METROPOLITAN GOVERNMENT OF NASHVILLE AND DAVIDSON COUNTY

Metropolitan Historic Zoning Commission
Sunnyside in Sevier Park
3000 Granny White Pike
Nashville, Tennessee 37204
Telephone: (615) 862-7970
Fax: (615) 862-7974

STAFF RECOMMENDATION
3616 Westbrook Avenue
April 16, 2014

Application: New construction-addition
District: Richland-West End Neighborhood Conservation Zoning Overlay
Council District: 24
Map and Parcel Number: 10405022000
Applicant: Gilbert McLaughlin Casella Architects, PLC
Project Lead: Paul Hoffman, paul.hoffman@nashville.gov

Figure 3. Existing doorway to be removed and replaced with a window, returning the historic fenestration

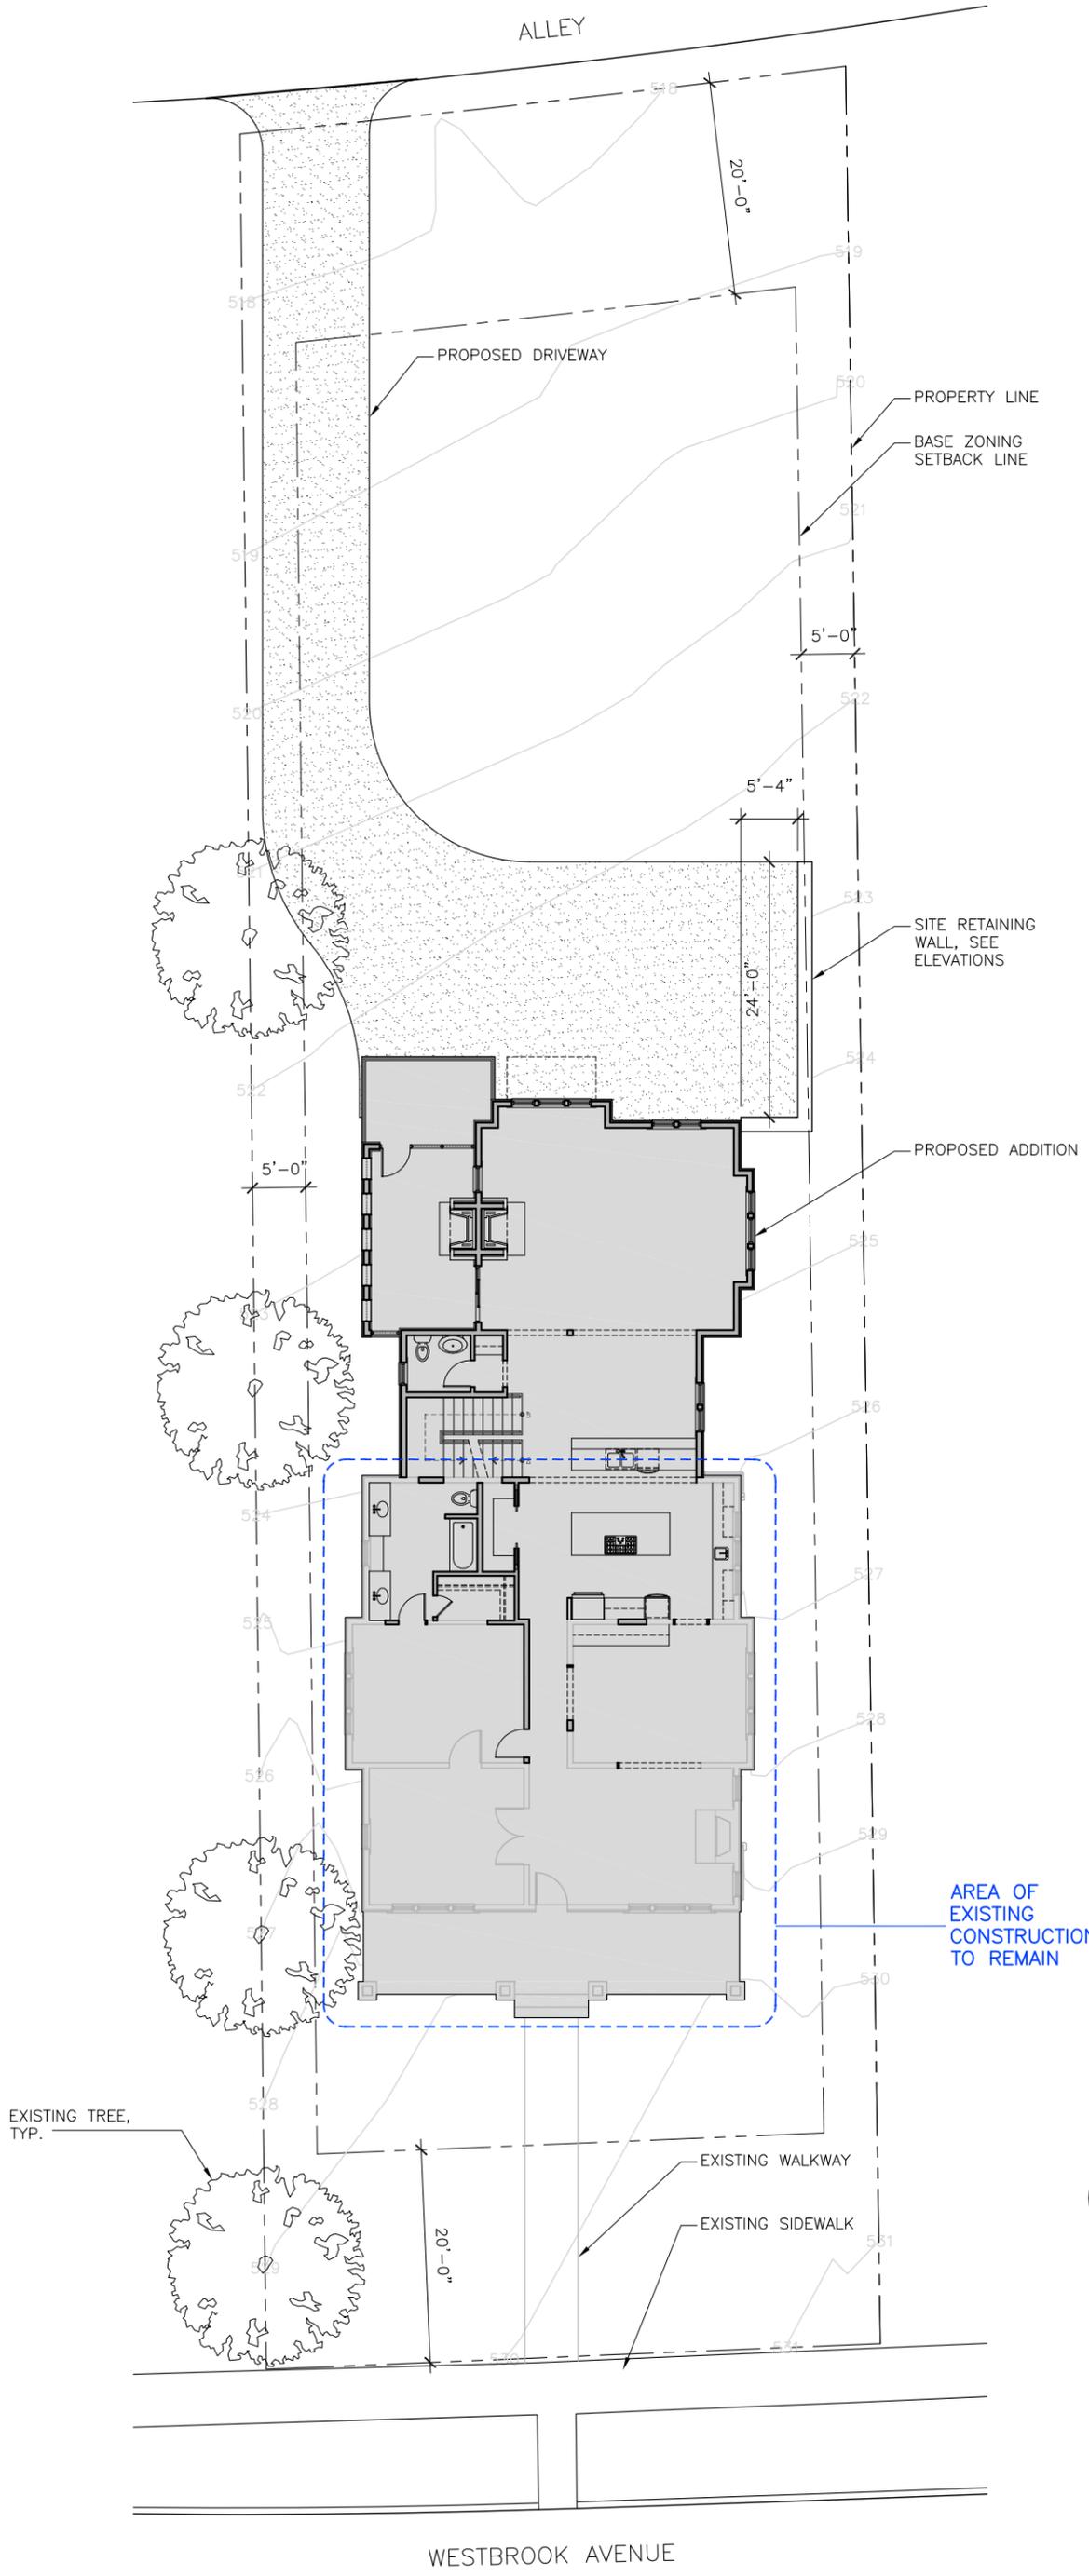
Proportion and Rhythm of Openings: The applicant proposes to remove the doorway on the second story of the right side, and replace it with a window matching those on the rest of the house. The windows on the addition are at least twice as tall as they are wide, meeting the historic proportions of openings. There are no large expanses of wall space without a window or door opening. The five openings at the back of the west elevation are screened openings in the screened porch wall. Staff finds the project's proportion and rhythm of openings to meet Section II.B.1.g and II.B.2.

SITE PLAN
 SCALE: 1/16" = 1' - 0"

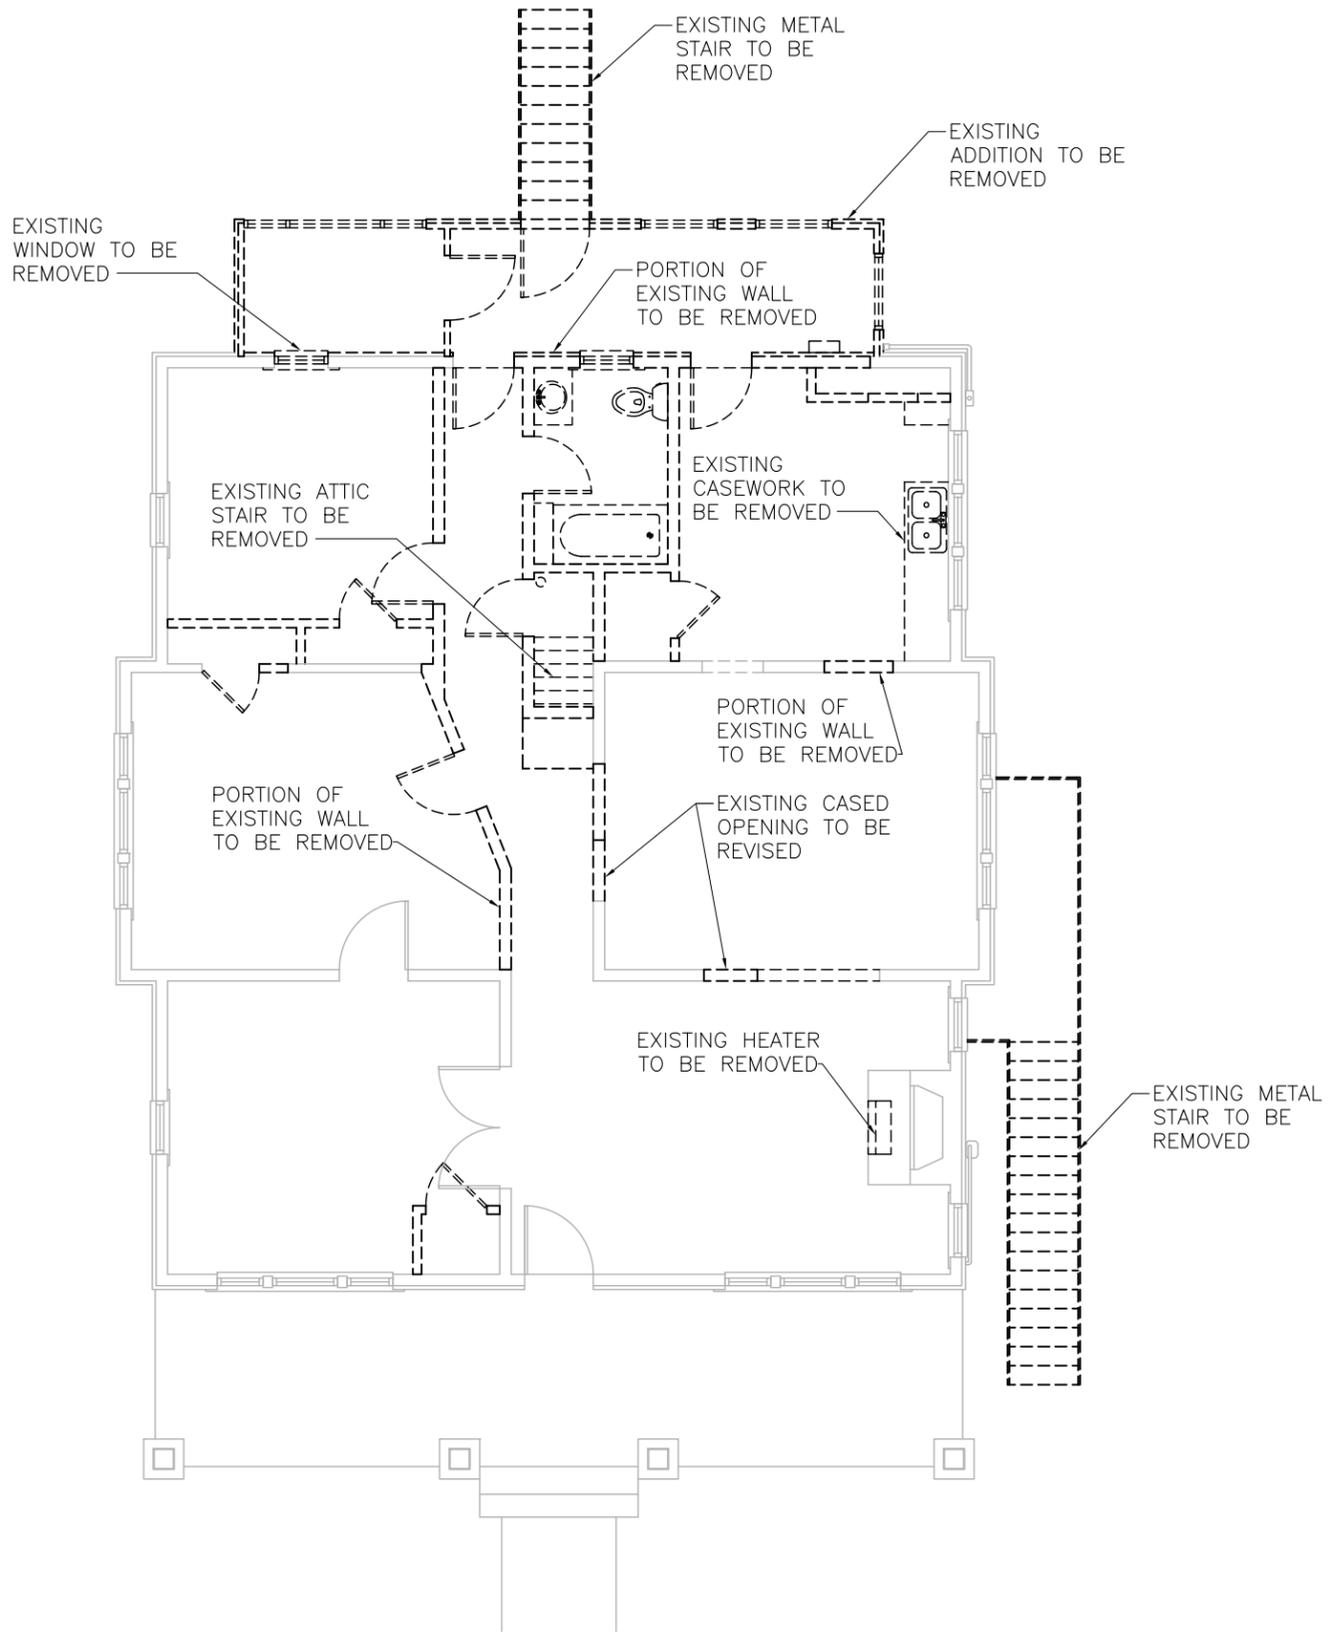
The proposed addition will be eighty-eight feet (88') from the rear property line and ten feet (10') from the sides. It meets zoning requirements of twenty feet (20') at the rear and five feet (5') from the sides. The project meets section II.B.1.c and II.B.2.

Appurtenances & Utilities: A paved driveway is proposed from the addition to the alley. The existing driveway from Westbrook Avenue will be removed as it is now on a neighboring lot after a recent subdivision. A retaining wall will be built at the eastern side of the driveway. The location of the HVAC and other utilities was not noted. Staff asks that the HVAC be located on the rear façade or on a side façade beyond the

midpoint of the house if it needs to be relocated. The project meets section II.B.1.i and II.B.2.

Recommendation Summary: Staff recommends approval with the condition of final approval of a brick sample, windows, doors and garage doors prior to their purchase and installation and with the condition that the HVAC be located on the rear façade, or on a side façade beyond the midpoint of the house.

ENTRY LEVEL DEMOLITION PLAN

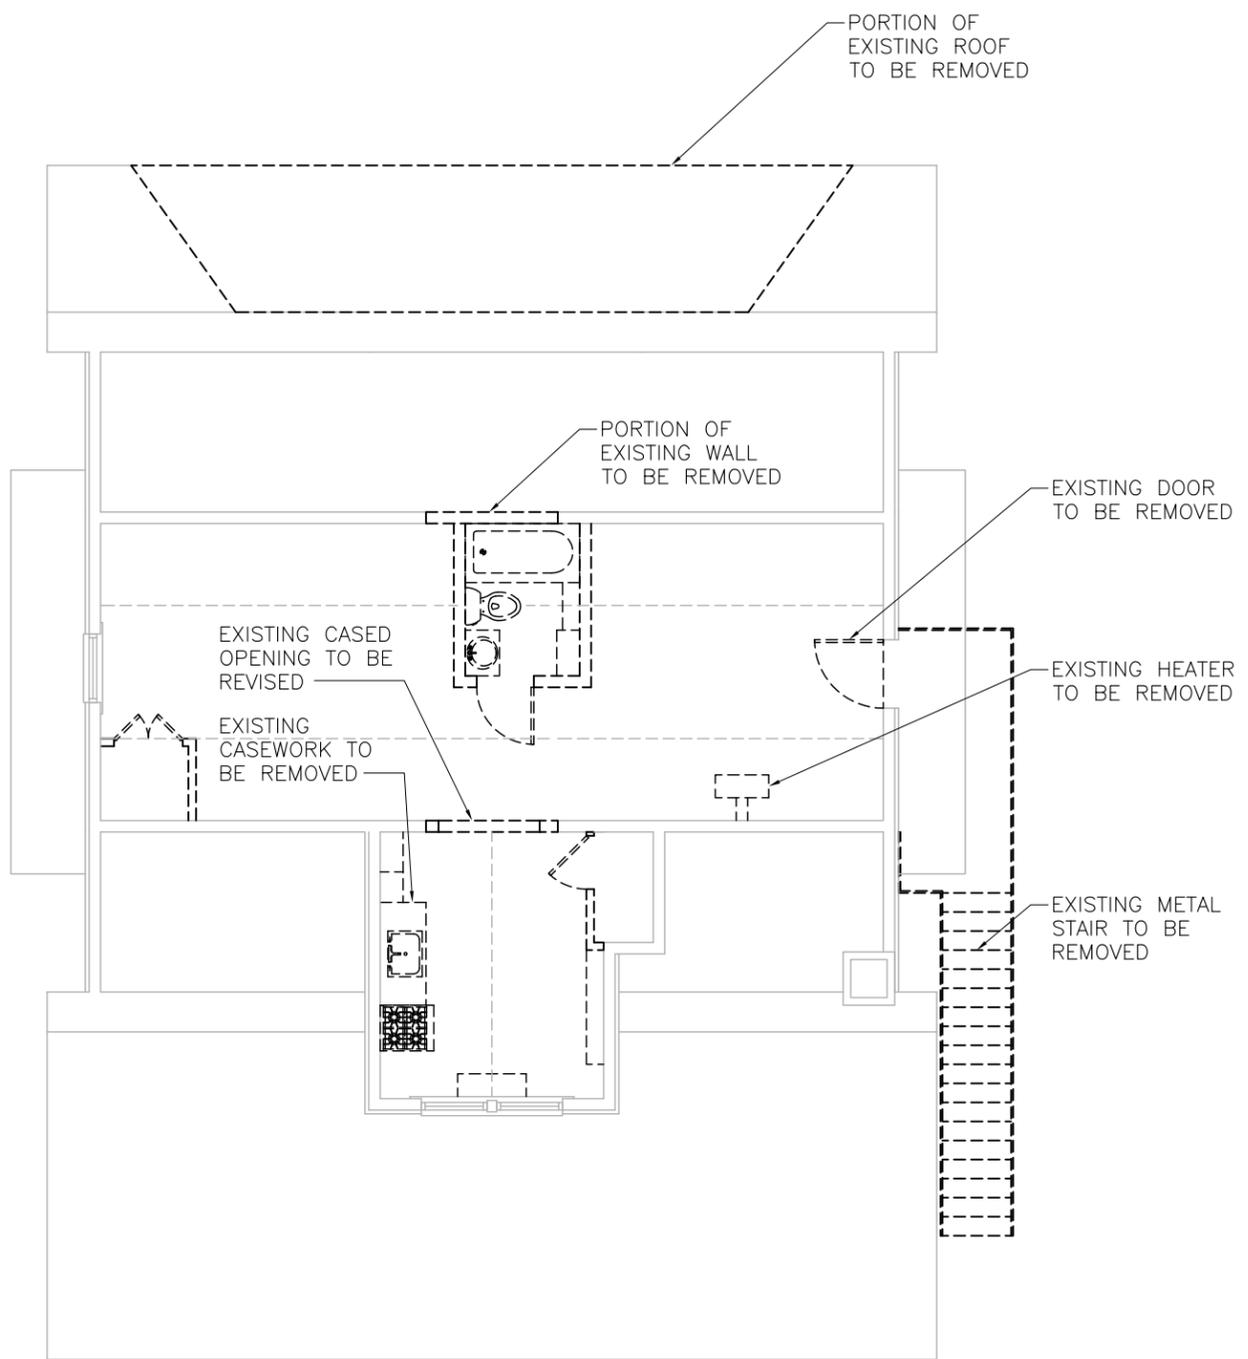
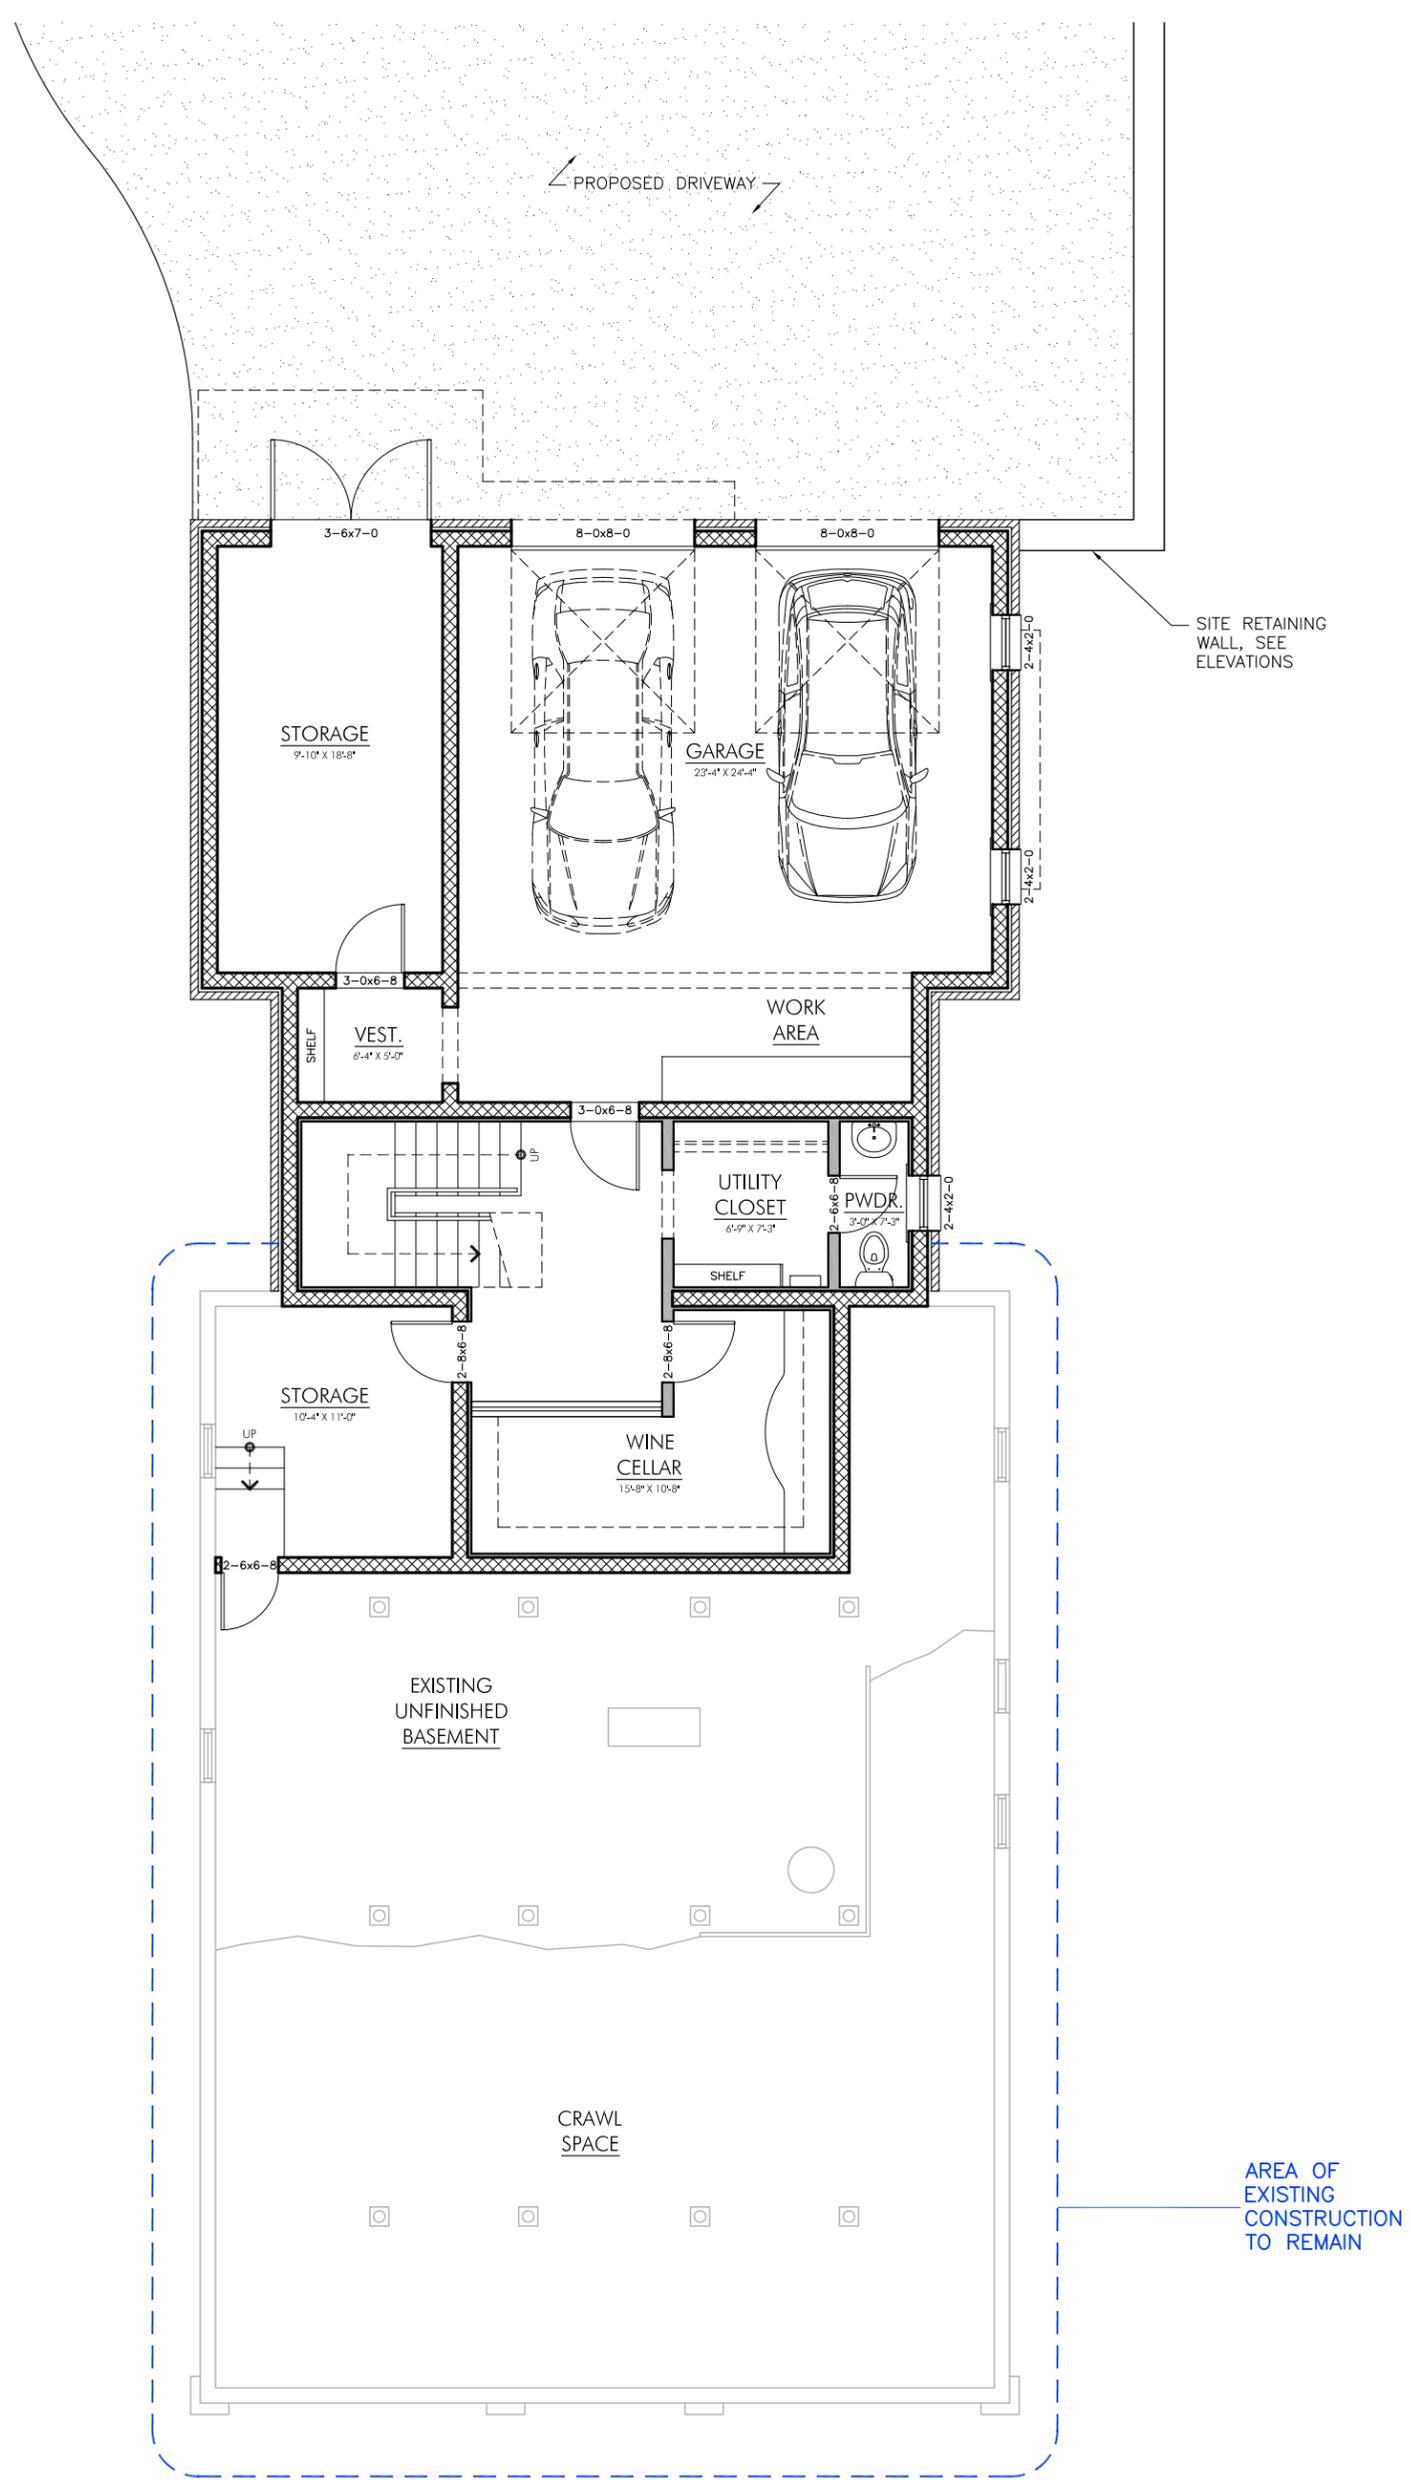
Demolition: This project calls for the removal of two sets of exterior metal stairs and demolition of an existing rear addition (see Figure 2). This will also require that the second level doors be removed and replaced with windows, which recreates a more historic condition. Staff finds that the addition and the staircase are not original and do not contribute to the historic character of the historic house. This partial demolition is not detrimental to the historical integrity of the building or the district and meets section III.B.2 for appropriate demolition and does not meet section III.B.1 for inappropriate demolition.
